# Teviot Wind Farm

## Turbine Modifications

**Figure 5: Comparative Wireline Showing Scoping Layout and Current Layout in views from North of Hawick on the A7 (Viewpoint 4).**

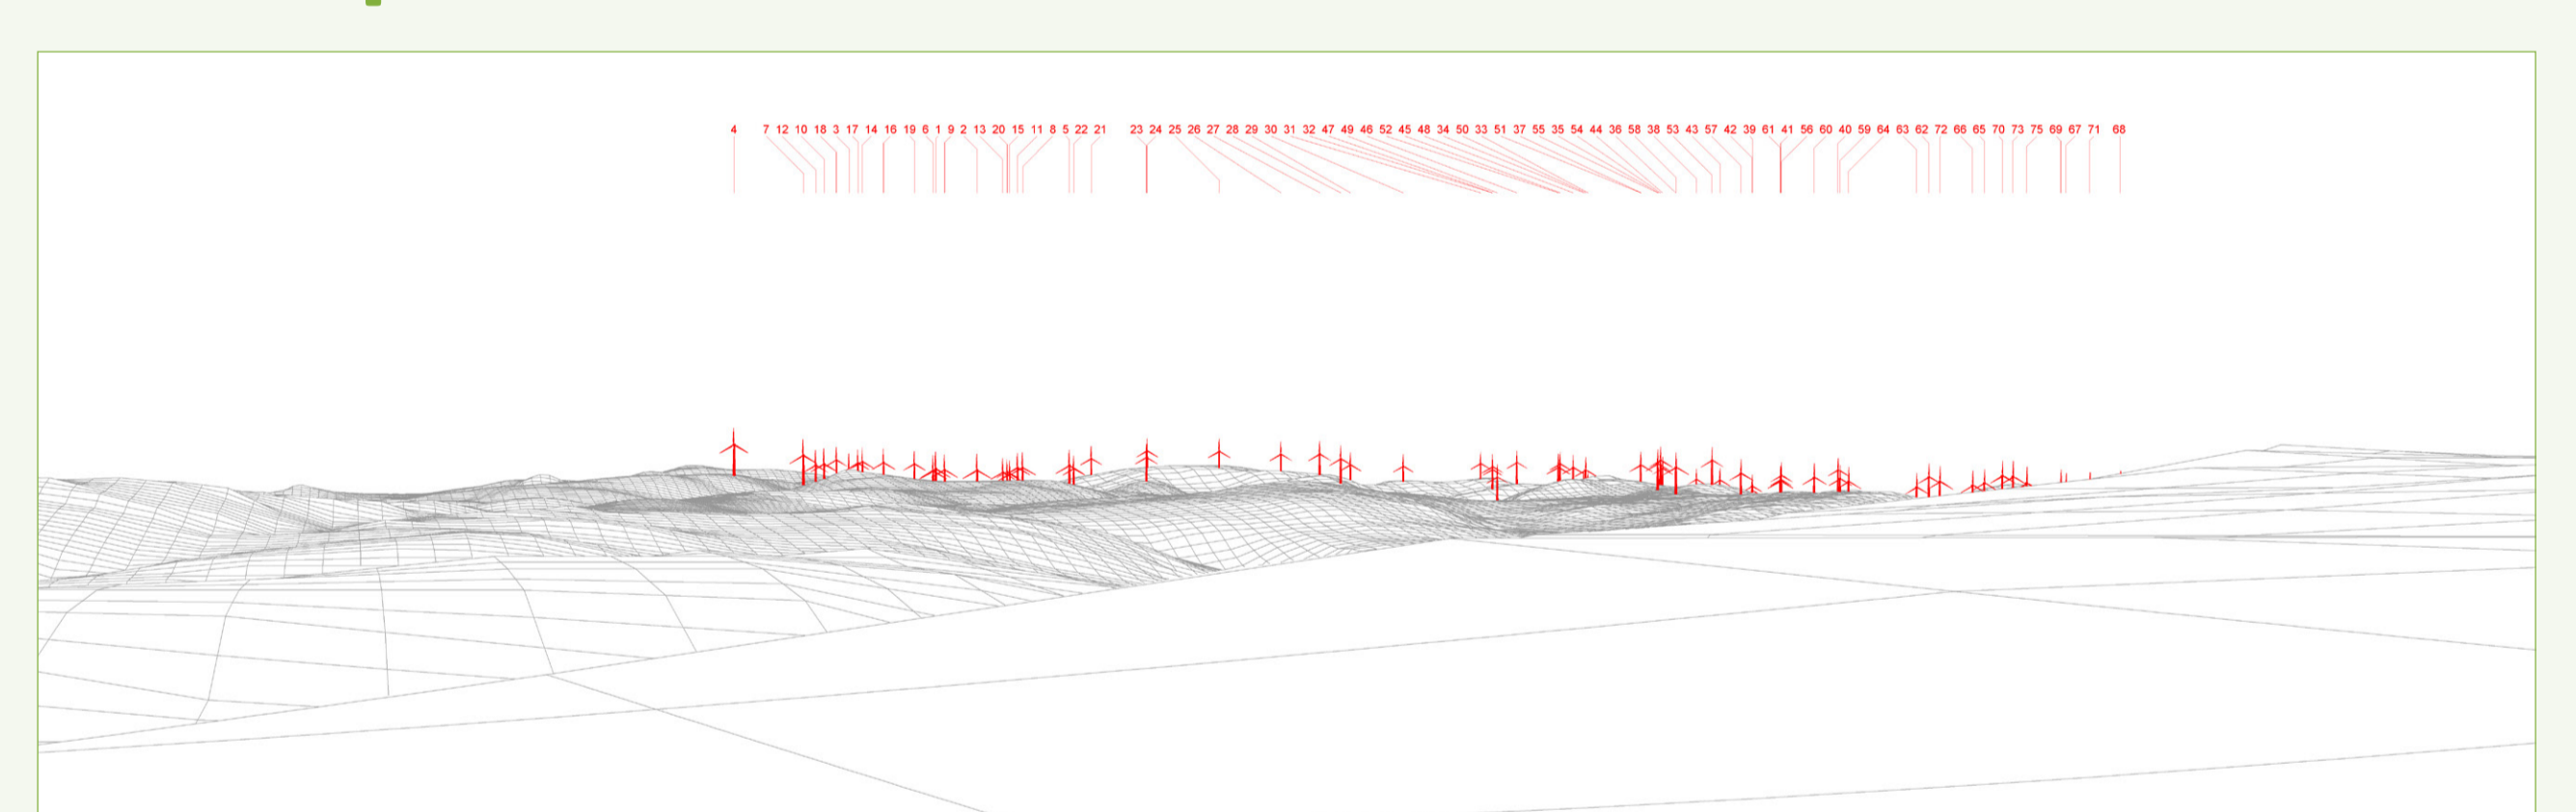
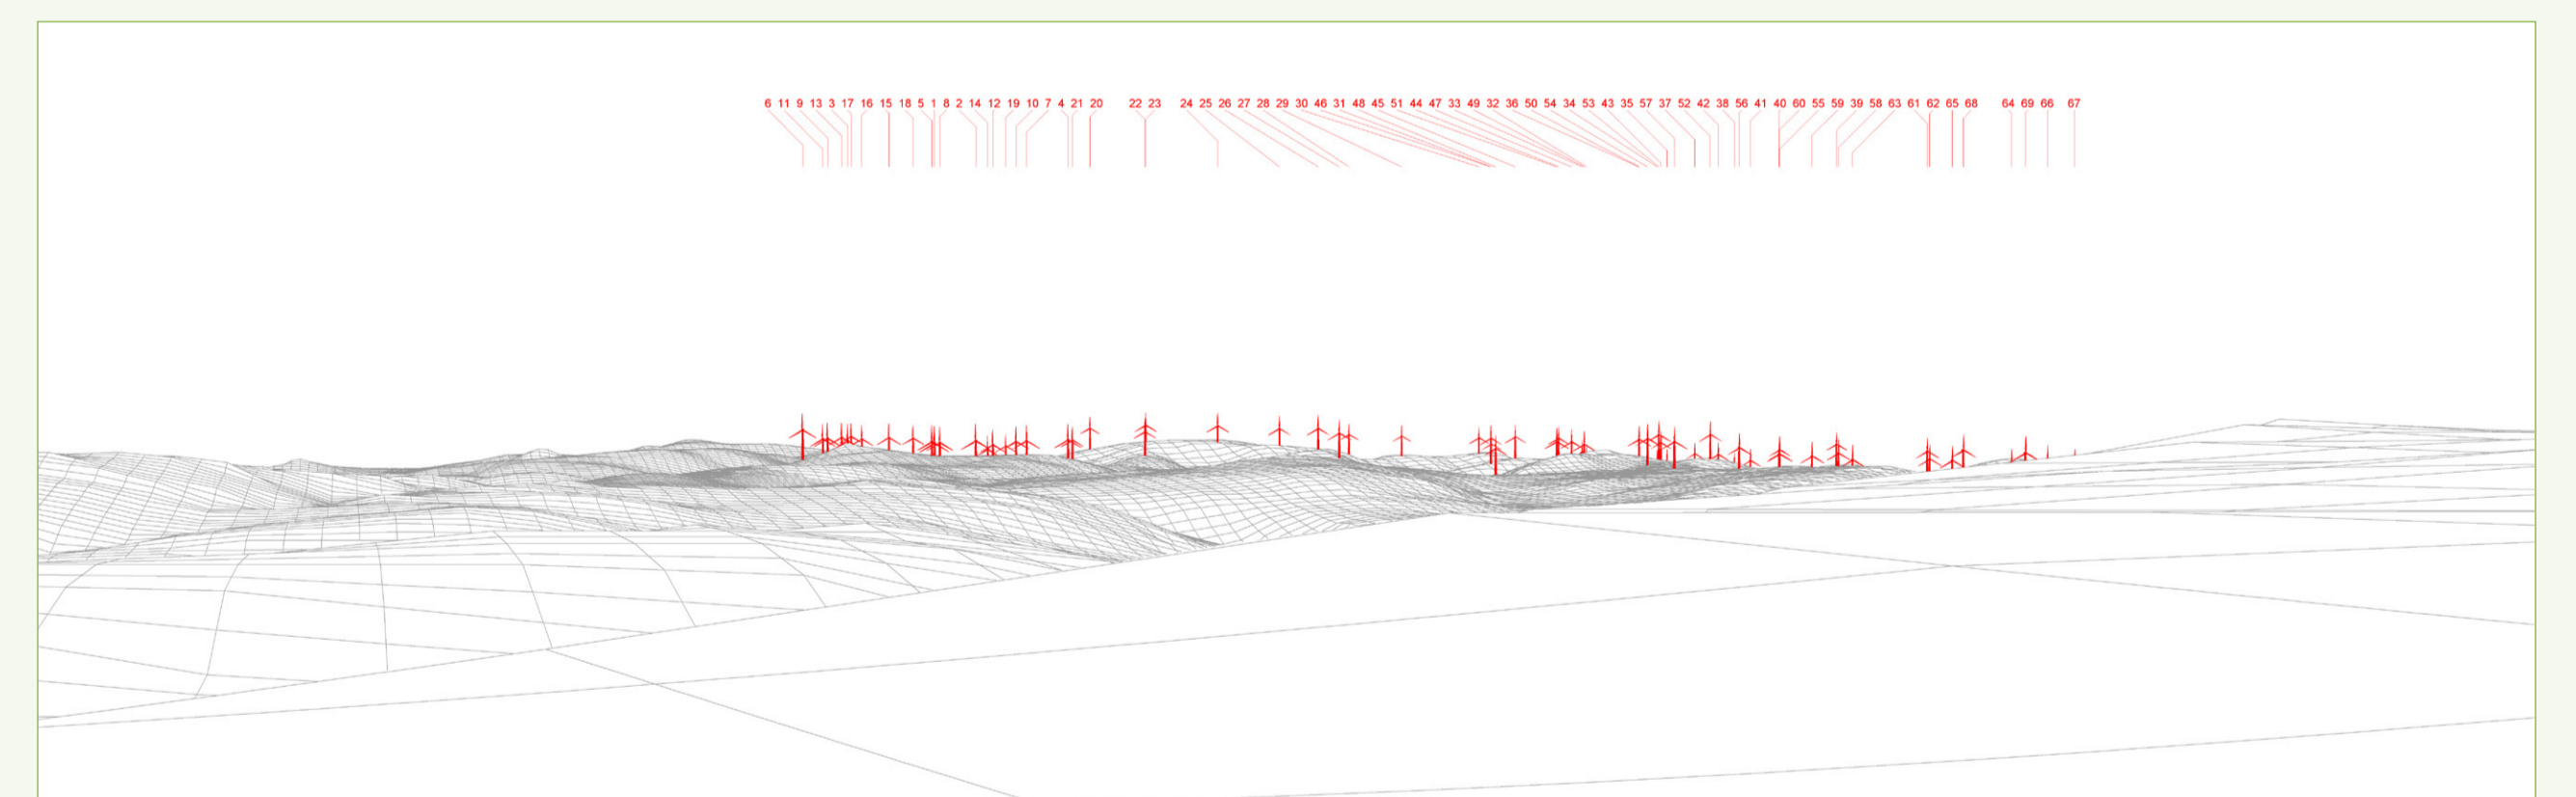
The comparative wirelines shown in **Figures 4** and **5** below illustrate the positive benefits that removing the six turbines has had on views from around Teviothead and to the north of Hawick from the A7.
